END OF ADDENDUM NUMBER ONE (1)

CIVIL PLANS	
CCD PROJECT	23043.10
DATE ISSUED	August 6, 2024
DATE REVISED	August 15, 2024
#	1

CLINTON PARKS - PHASE I
 CITY OF CLINTON
 TRACEWAY PARKS & KIDS TOWNE PARK

DRAWING NO.
P102 R1

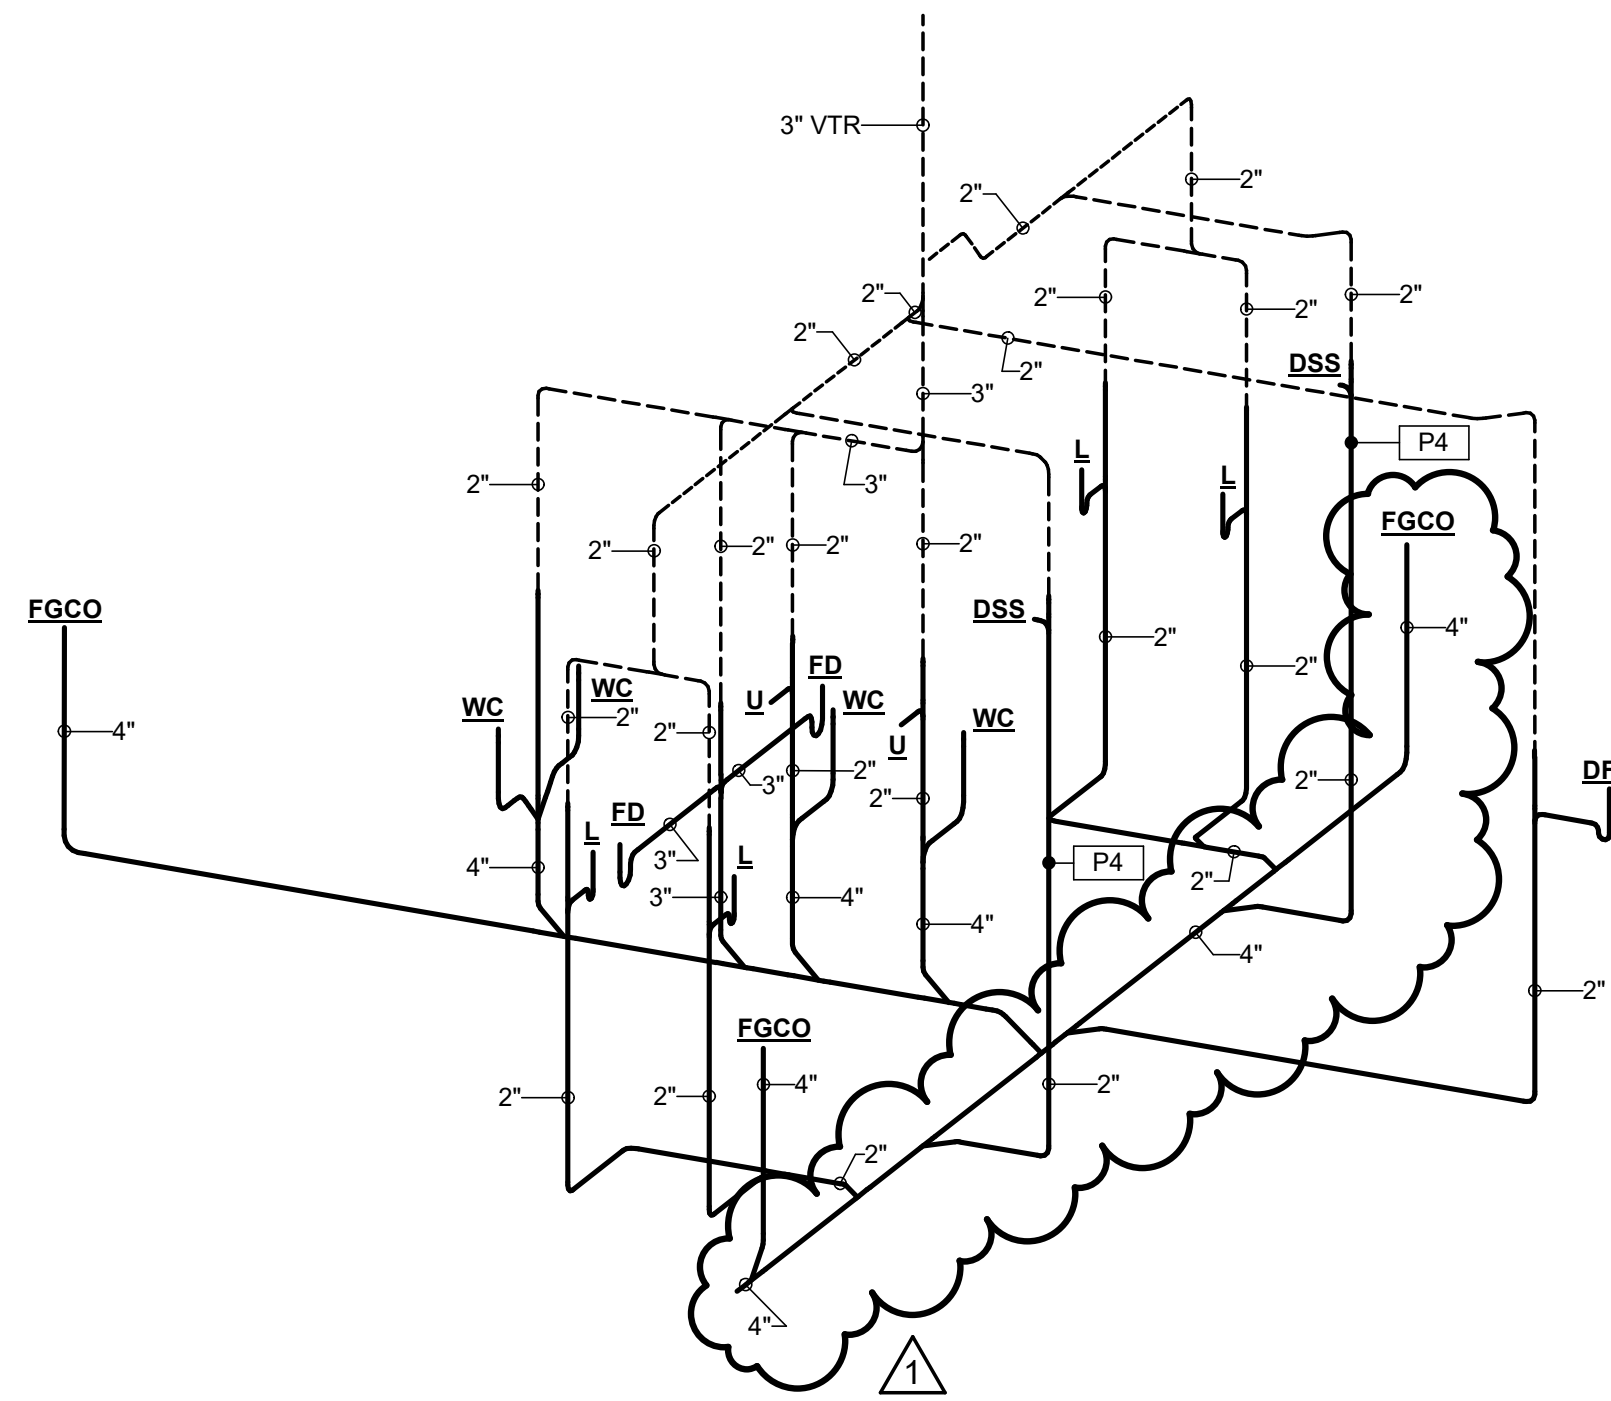
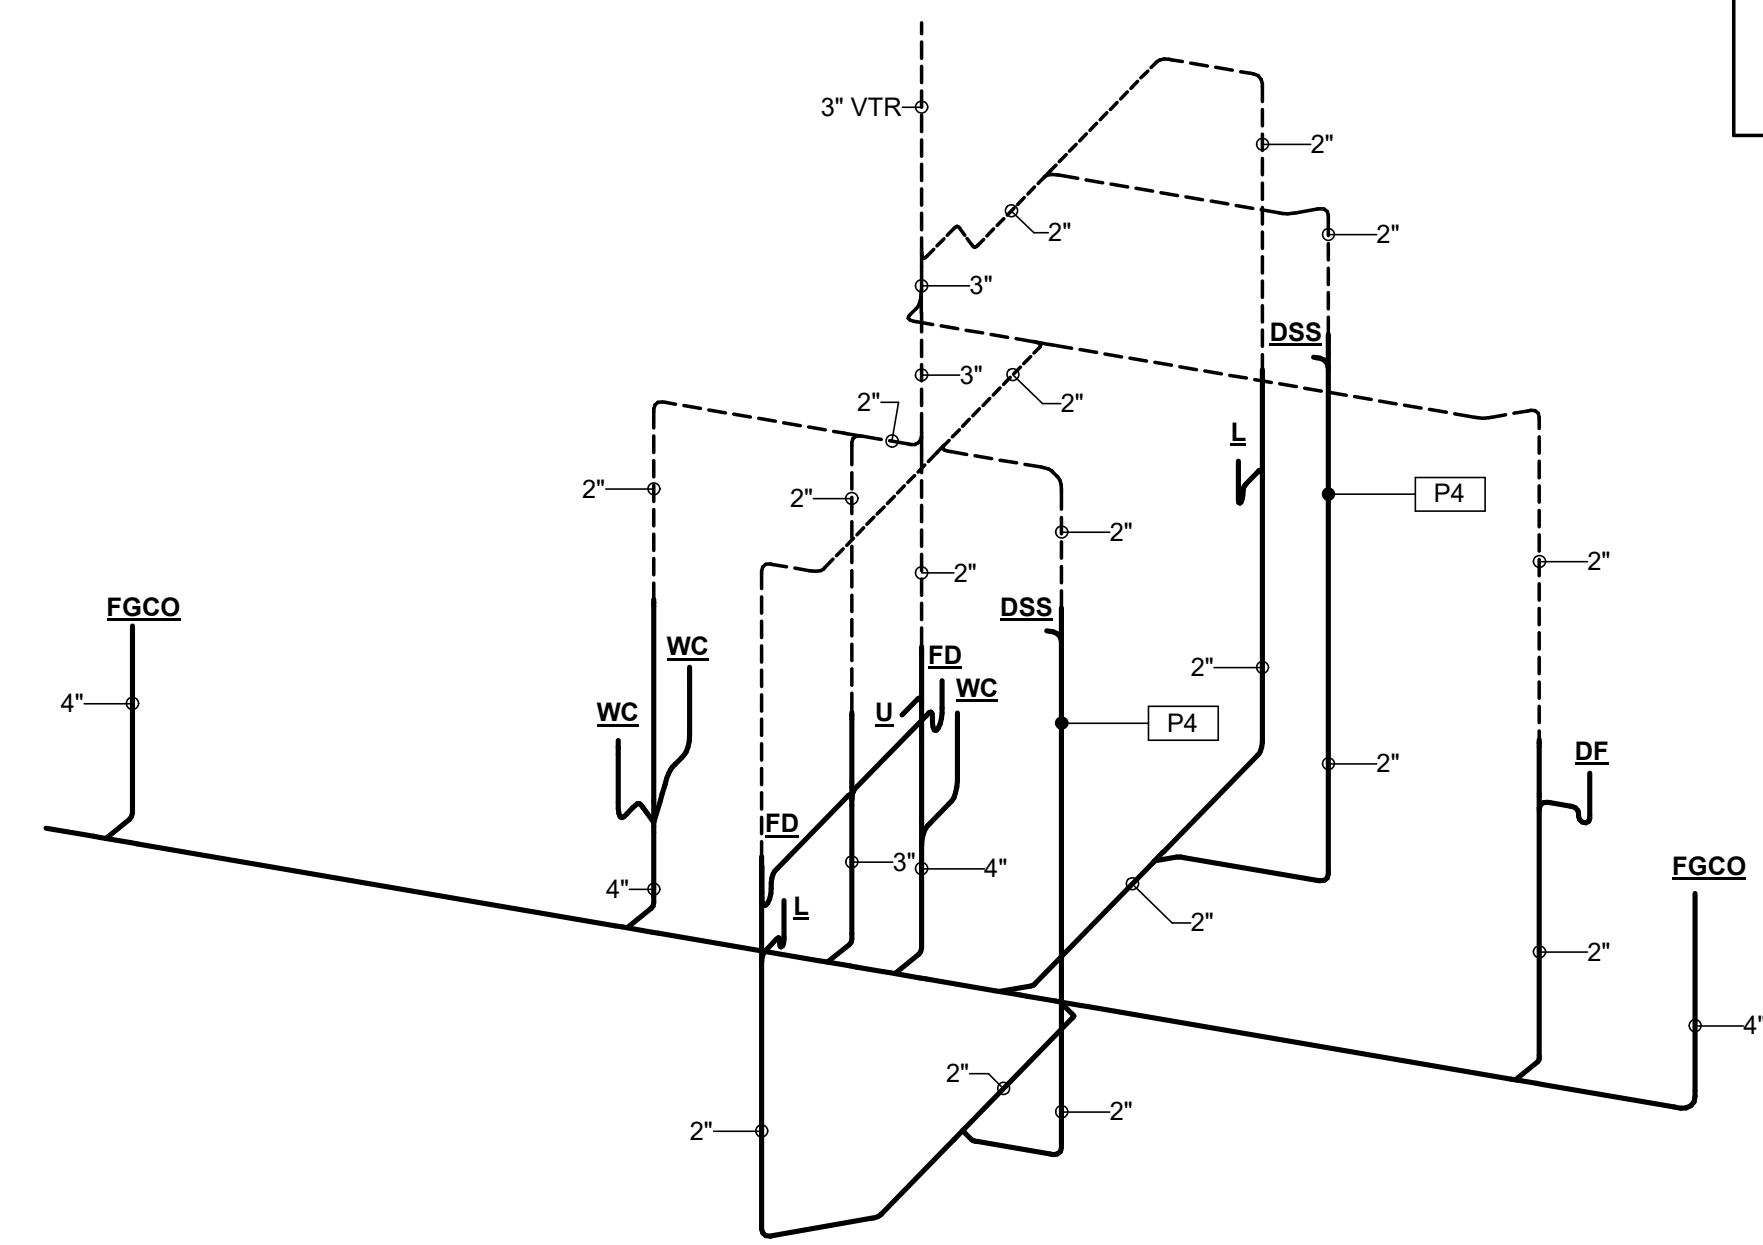
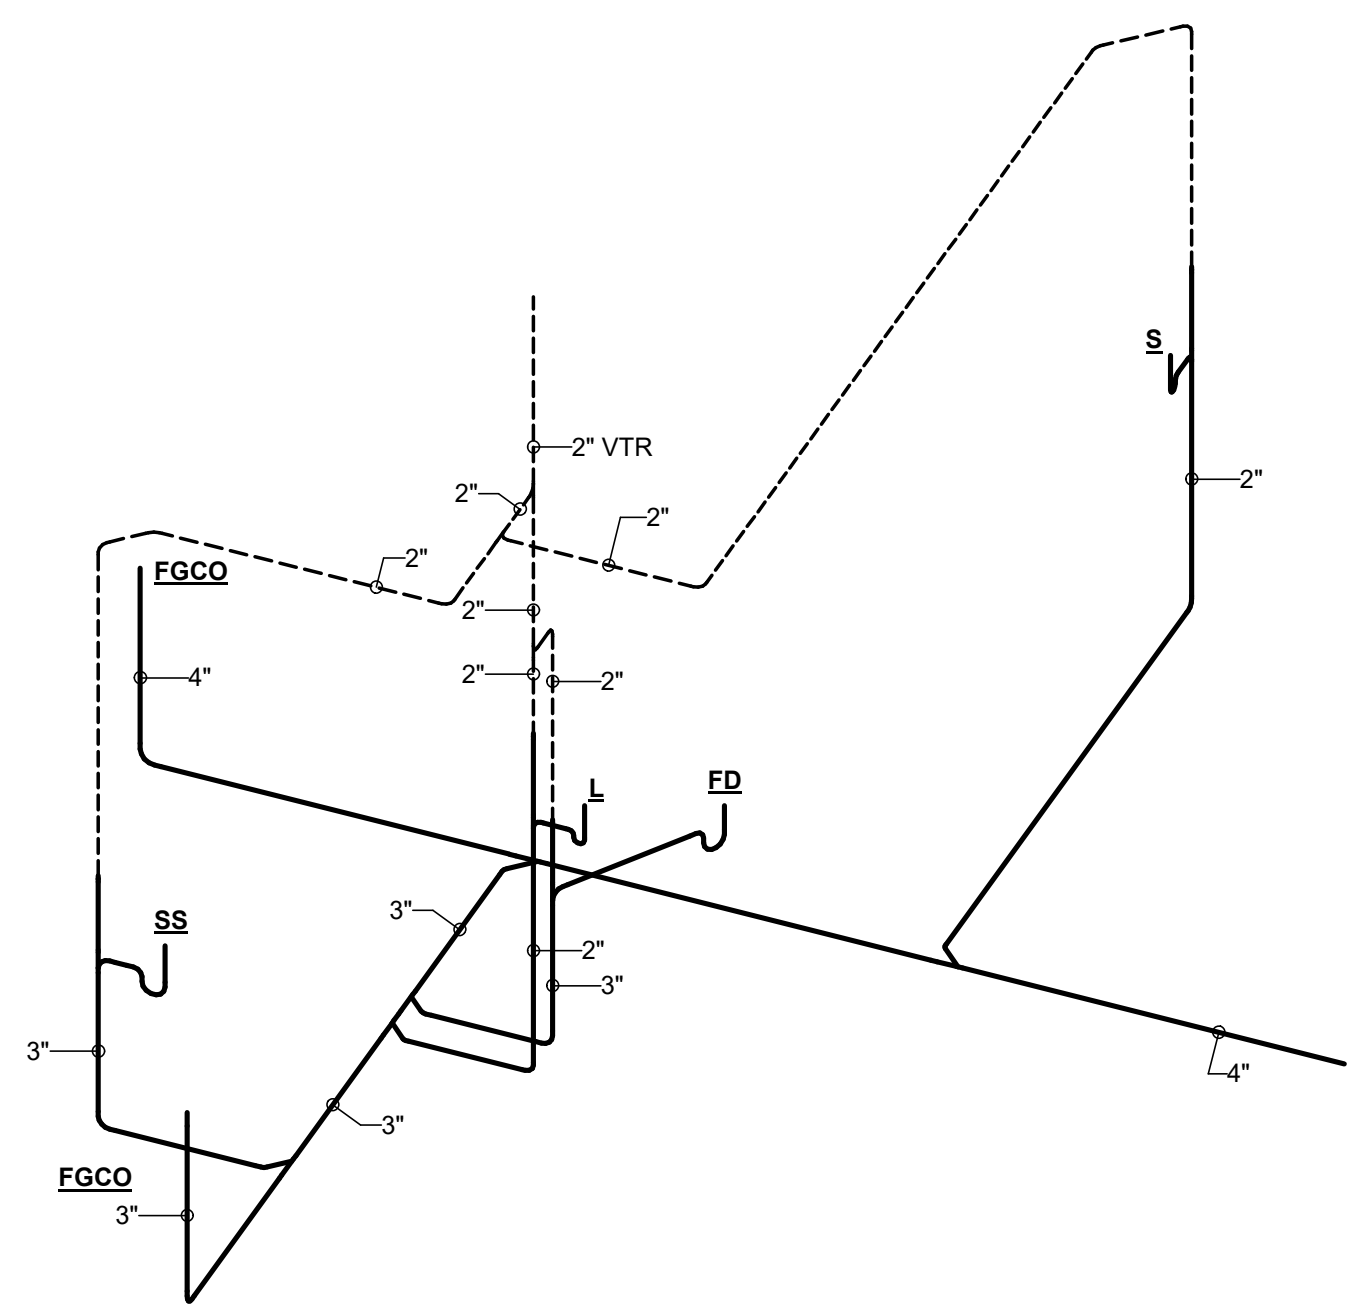
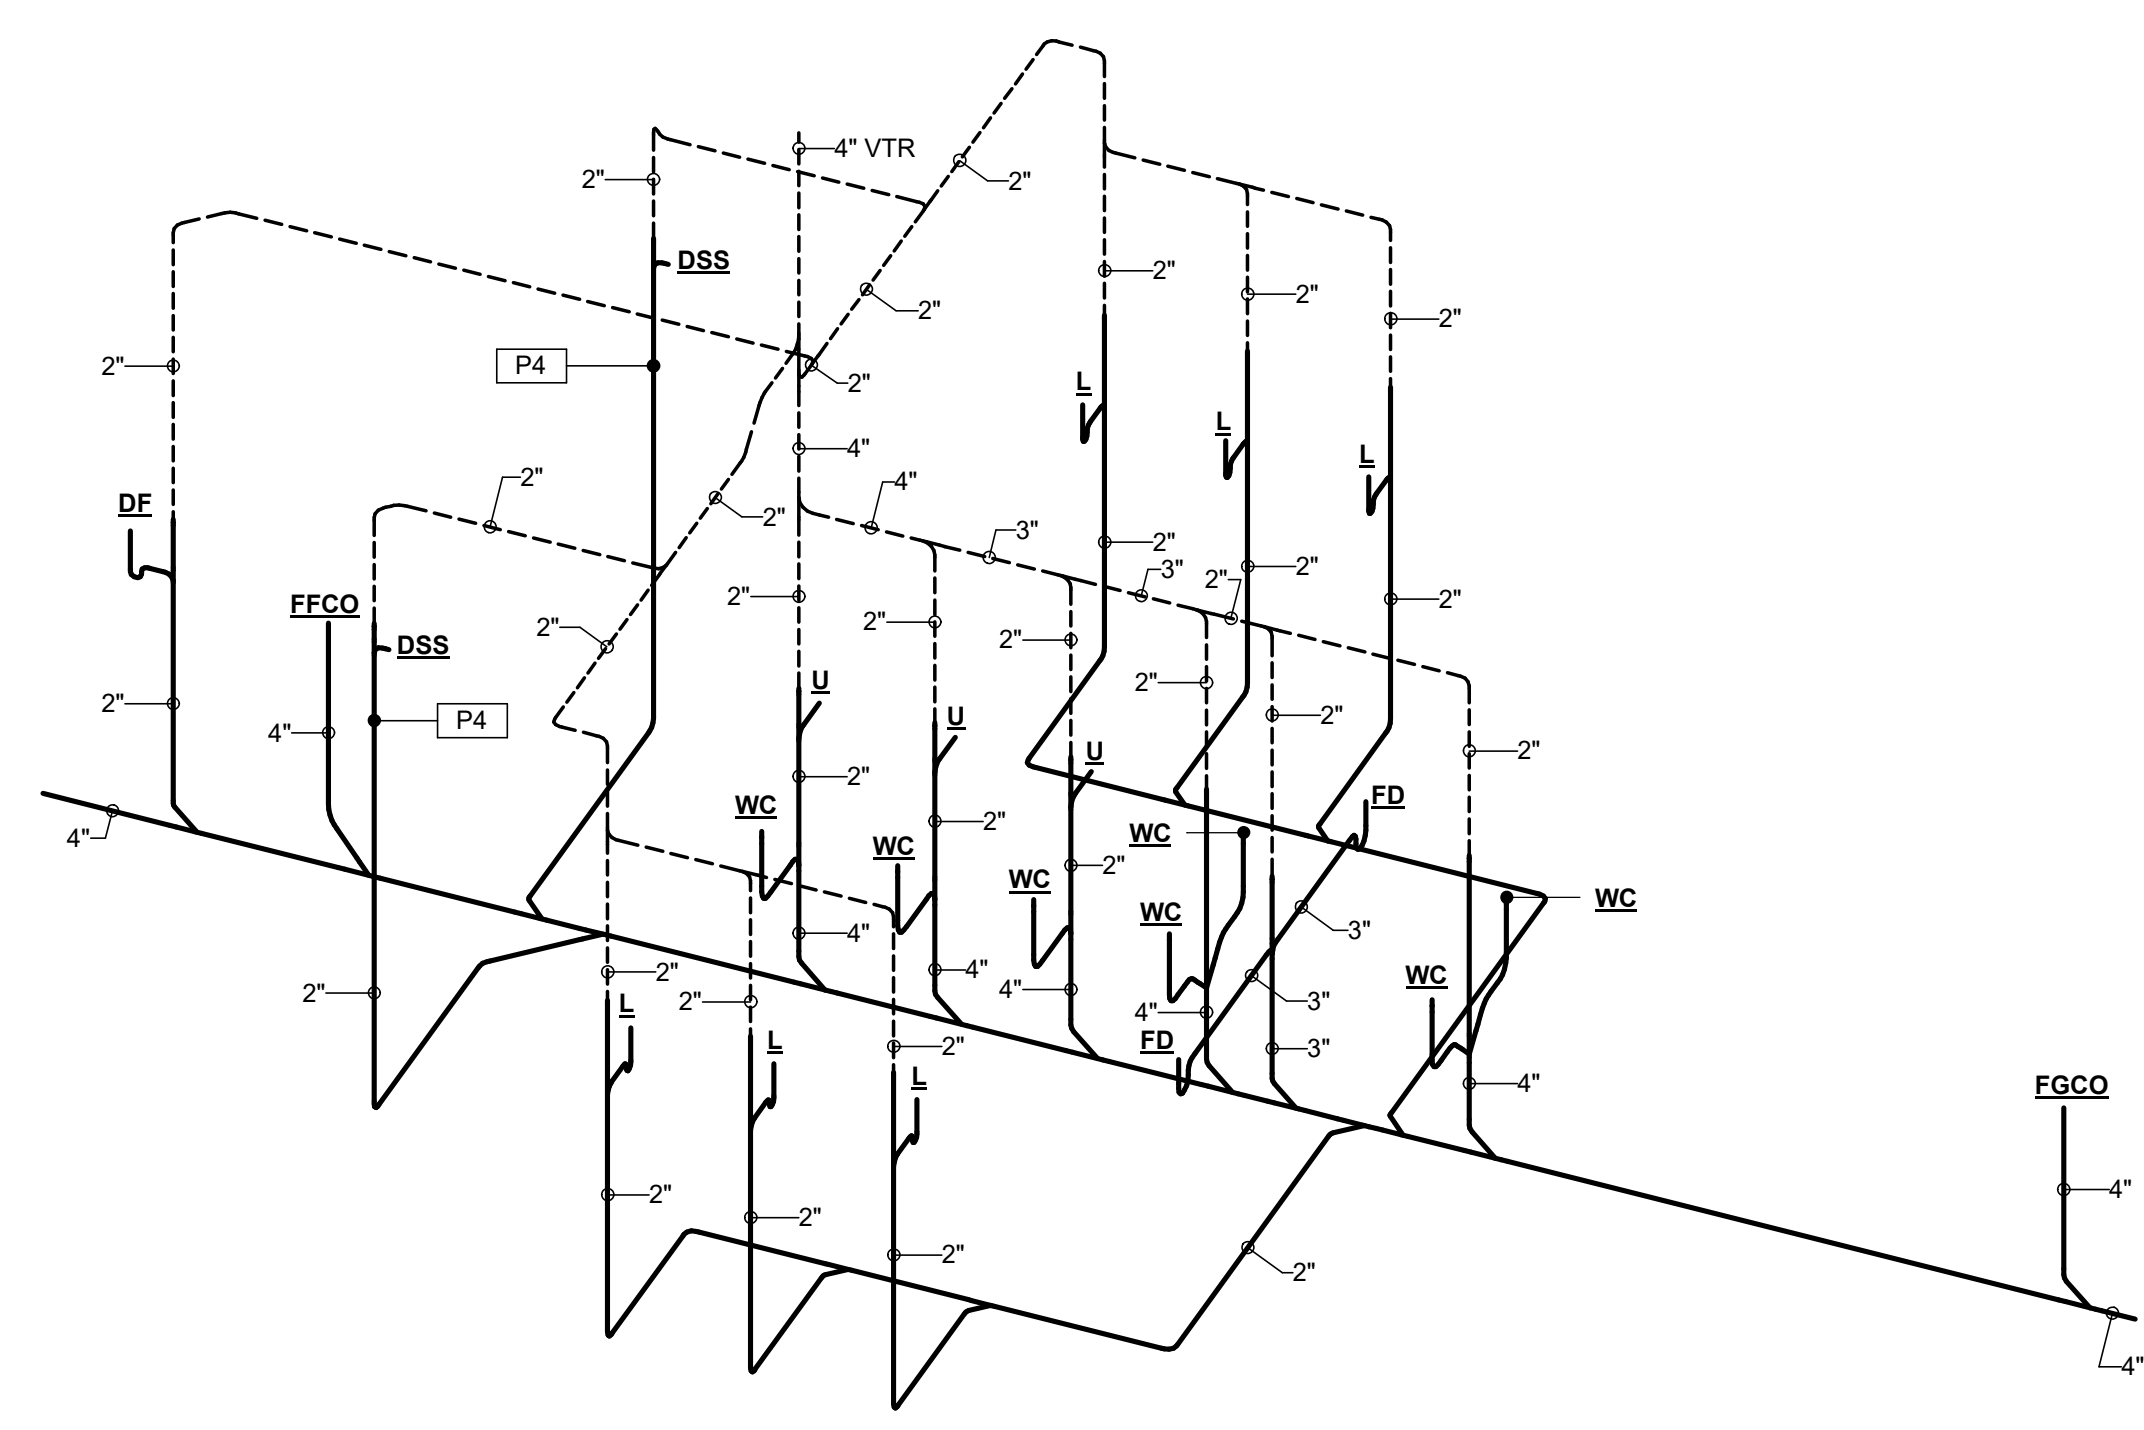
16. **DRAWING P101, PLUMBING PLANS** – Replace with attached P101 R1 dated as revised August 15, 2024.
17. **DRAWING P102, PLUMBING RISERS** – Replace with attached P102 R1 dated as revised August 15, 2024.
